2	11/26/25	ADD SCD RM-3.1

BRIDGE NO. CUY-77-15.46
IR 77 OVER WOODLAND AVE.

ESTIMATED QUANTITIES
BRIDGE NO. CUY-77-15.46
IR 77 OVER WOODLAND AVE.

GENERAL PLAN
BRIDGE NO. CUY-77-15.62
IR 77 OVER E. 22ND ST.

E. 14th ST.
REAR LEFT

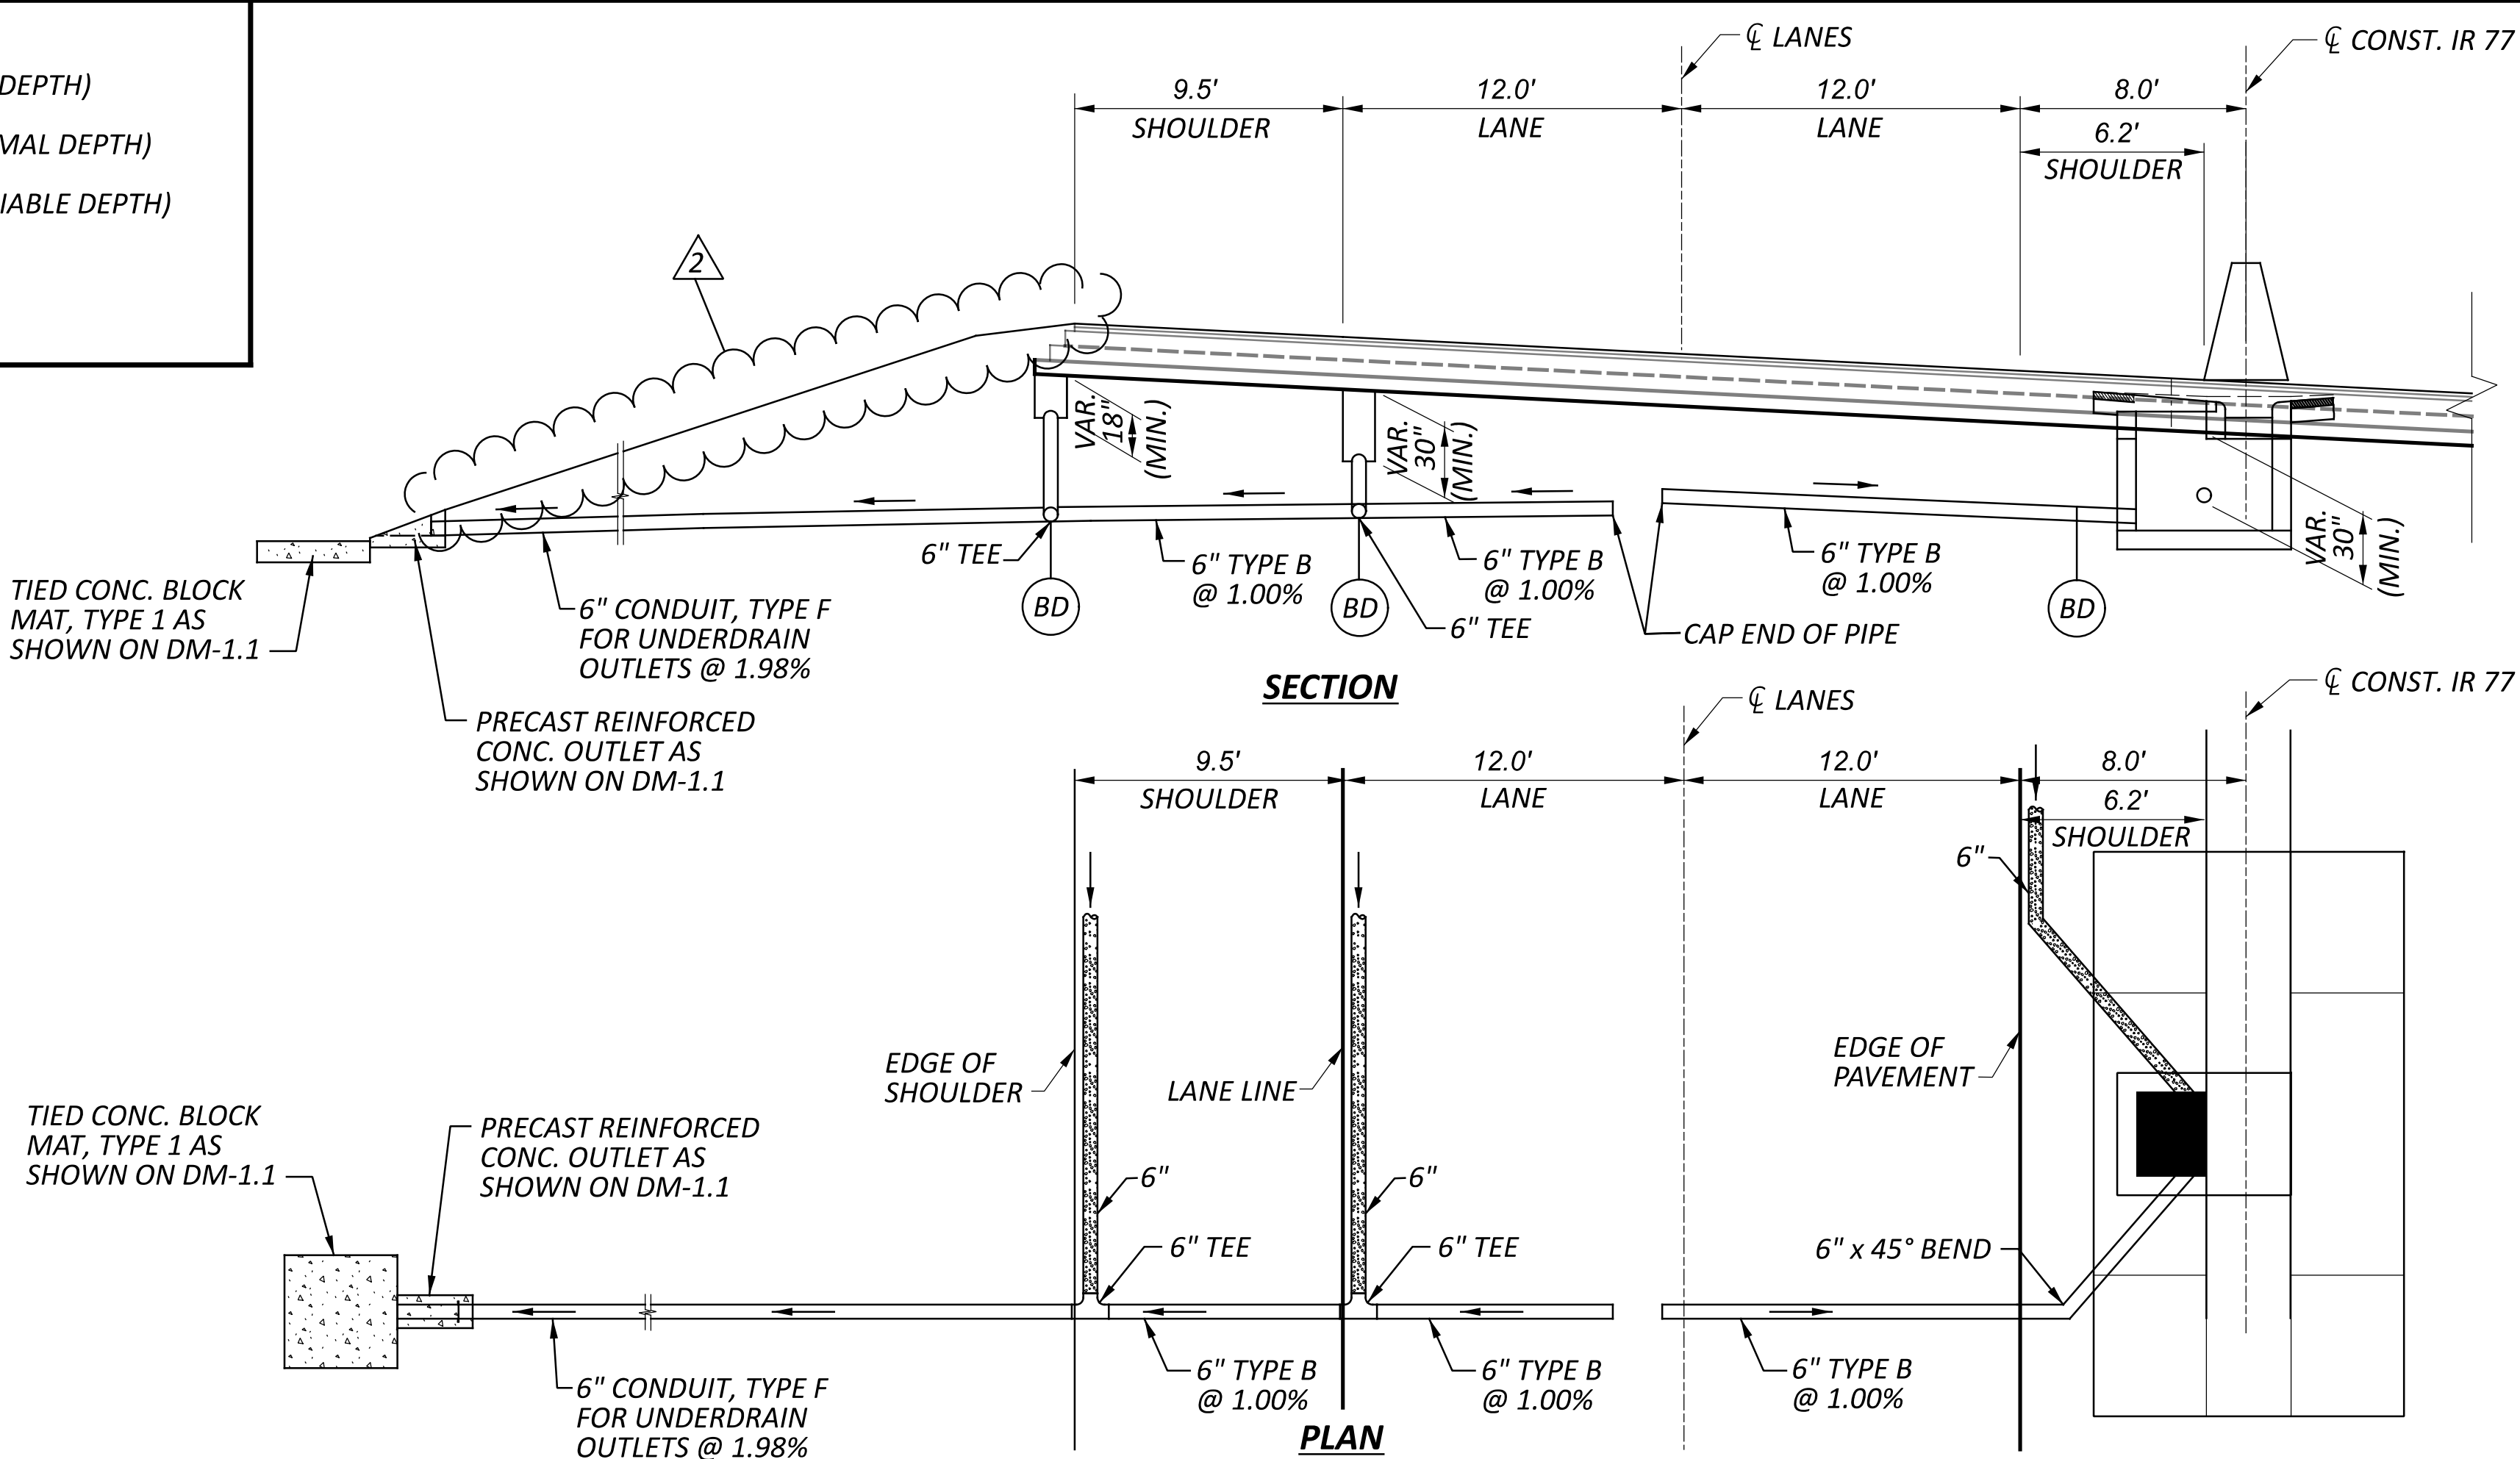
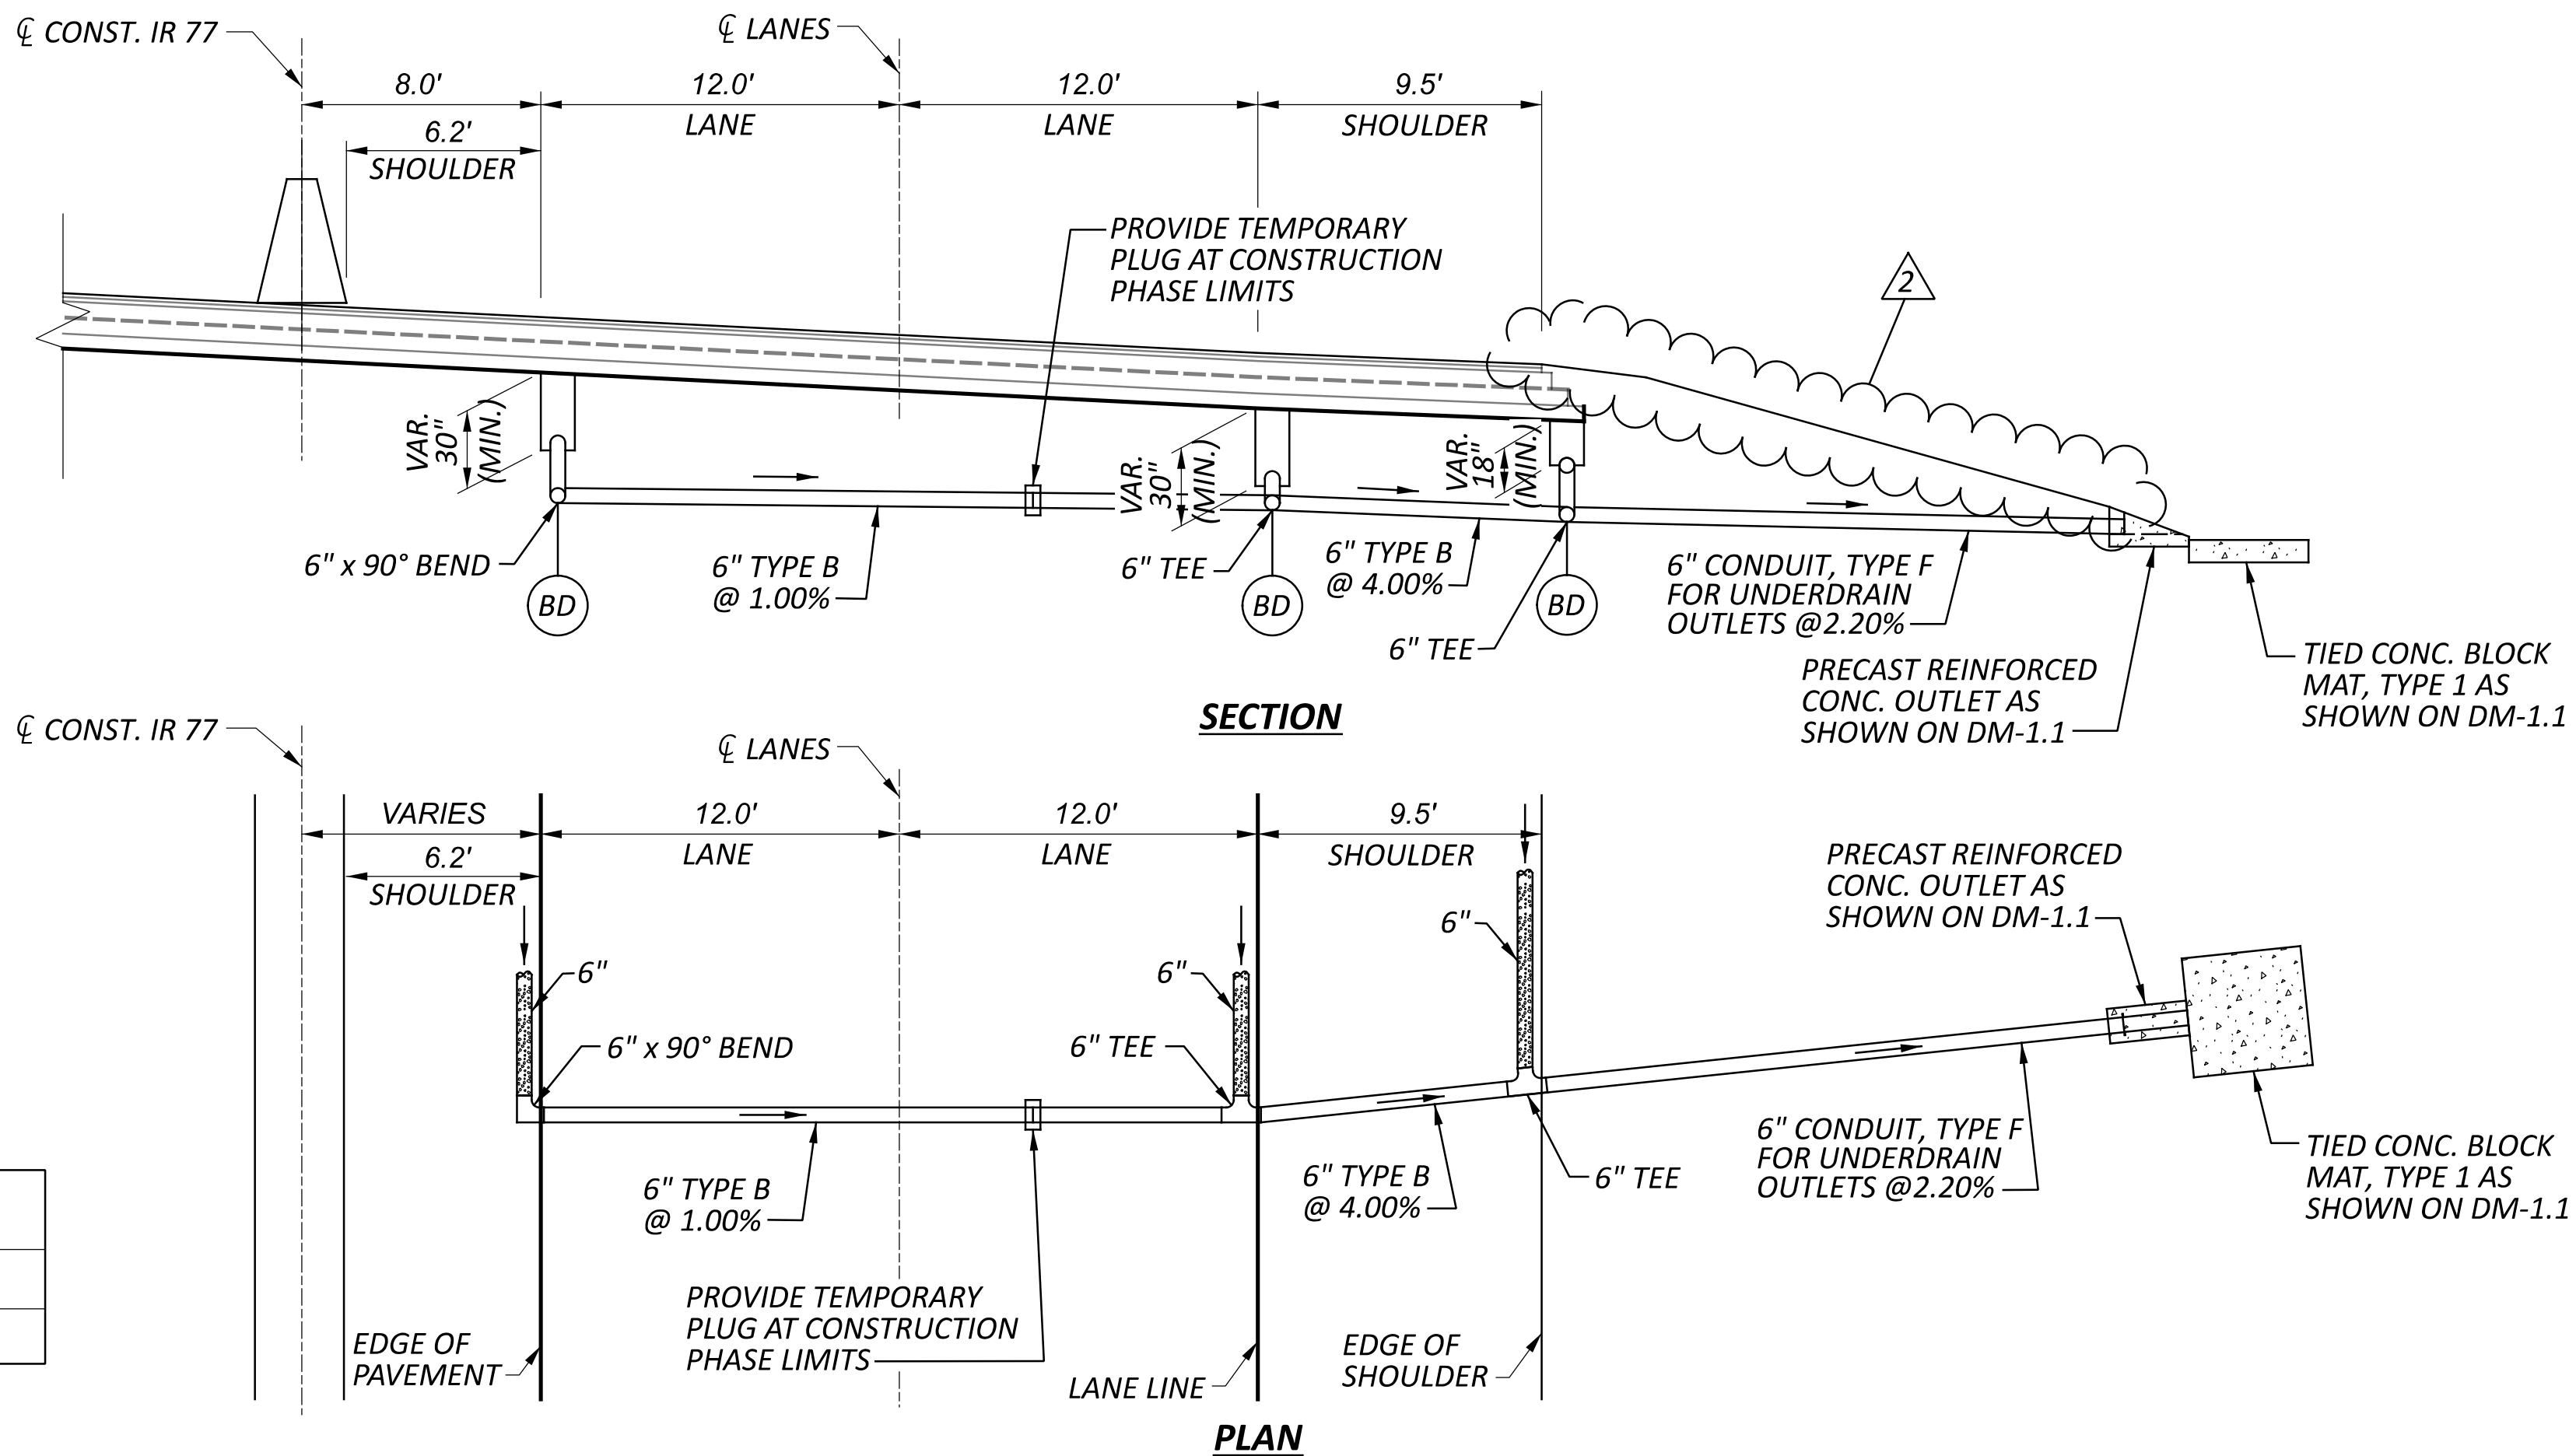
11/26/25	REVISE SLOPE
